Project	<b>IEEE 802.16 Broadband Wireless Access Working Group</b> < <a href="http://ieee802.org/16">http://ieee802.org/16</a> >	
Title	<b>Relay MAC PDU Construction in centralized security scenario</b>	
Date Submitted	<b>2007-08-25</b>	
Source(s)	Hang Zhang, Peiyong Zhu, Mo-Han Fong, Wen Tong, David Steer, Gamini Senarath, G.Q. Wang, Derek Yu, Israfil Bahceci, Robert Sun and Mark Naden Nortel 3500 Carling Avenue Ottawa, Ontario K2H 8E9	Voice: +613-763-1315 E-mail: wentong@nortel.com Voice: +613-765-8983 E-mail: pyzhu@nortel.com
Re:	IEEE P802.16j/D1: IEEE 802.16j working group letter ballot #28	
Abstract		
Purpose	To incorporate the proposed text into the P802.16j/D1 Baseline Document	
Notice	<i>This document does not represent the agreed views of the IEEE 802.16 Working Group or any of its subgroups. It represents only the views of the participants listed in the "Source(s)" field above. It is offered as a basis for discussion. It is not binding on the contributor(s), who reserve(s) the right to add, amend or withdraw material contained herein.</i>

# Relay MAC PDU Construction in Centralized Security Scenario

Figure 1. R-MAC PDU construction in centralized security scenario.

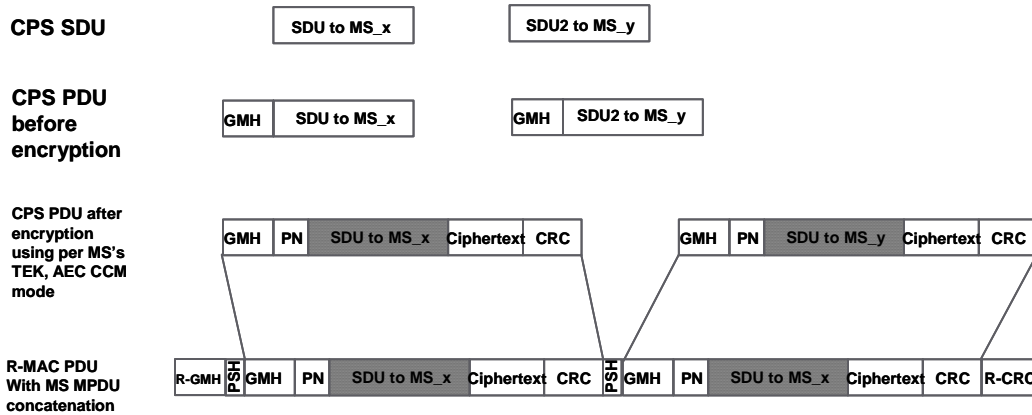
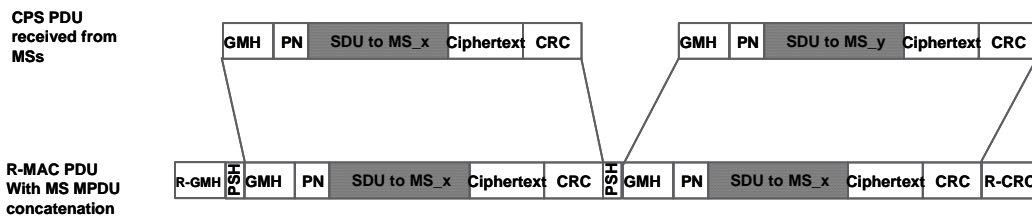
The R-MAC PDU construction, i.e., fragmentation and packing of MS encrypted MPDUs, follows the same rules defined for MS MPDU construction. The only difference is that the definition of fragment sequence number (FSN) in fragmentation sub-header (FSH) and packing sub-header (PSH). In MPDU, the FSN is meaningful for one MS service flow. In R-MAC PDU, the FSN is meaningful for a particular QoS class or a transport tunnel which could carry an aggregated MS service flow. The FSN is set to each encrypted MS MPDU by R-MAC sub-layer of the source station in the forwarding path and is used to keep the order of MS

The R-MAC PDU construction with packing multiple MS MPDUs is shown in Figure 1.

Figure xxx. R-MAC PDU construction in centralized security scenario.

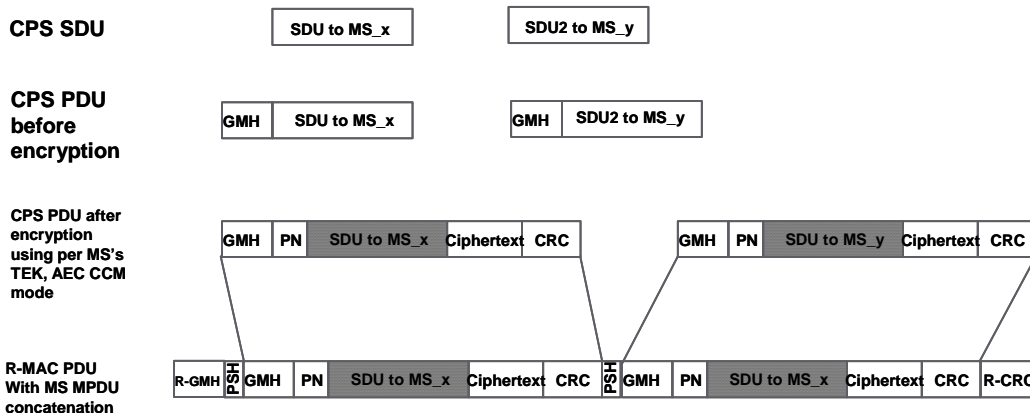
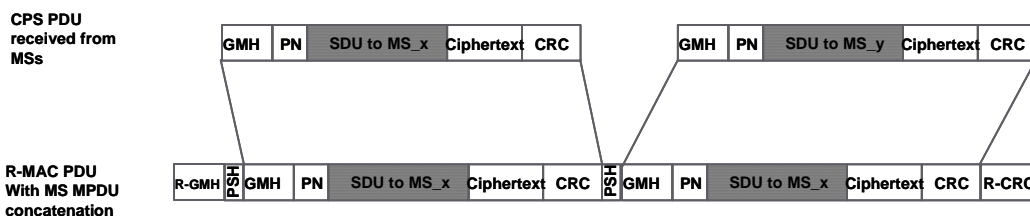
*[Add the following section 6.3.3.8.3 as indicated]*

#### 6.3.3.8.3 R-MAC PDU construction in relay network

##### 6.3.3.8.3.1 R-MAC PDU construction and forwarding in centralized security scenario

The R-MAC PDU construction, i.e., fragmentation and packing of MS encrypted MPDUs, follows the same rules defined for MS MPDU construction. The only difference is that the definition of fragment sequence number (FSN) in fragmentation sub-header (FSH) and packing sub-header (PSH). In MPDU, the FSN is meaningful for one MS service flow. In R-MAC PDU, the FSN is meaningful for a particular QoS class or a transport tunnel which could carry an aggregated MS service flow. The FSN is set to each encrypted MS MPDU by R-MAC sub-layer of the source station in the forwarding path and is used to keep the order of MS MPDUs between the two ends of forwarding path.

The R-MAC PDU construction with packing multiple MS MPDUs is shown in Figure xxx.
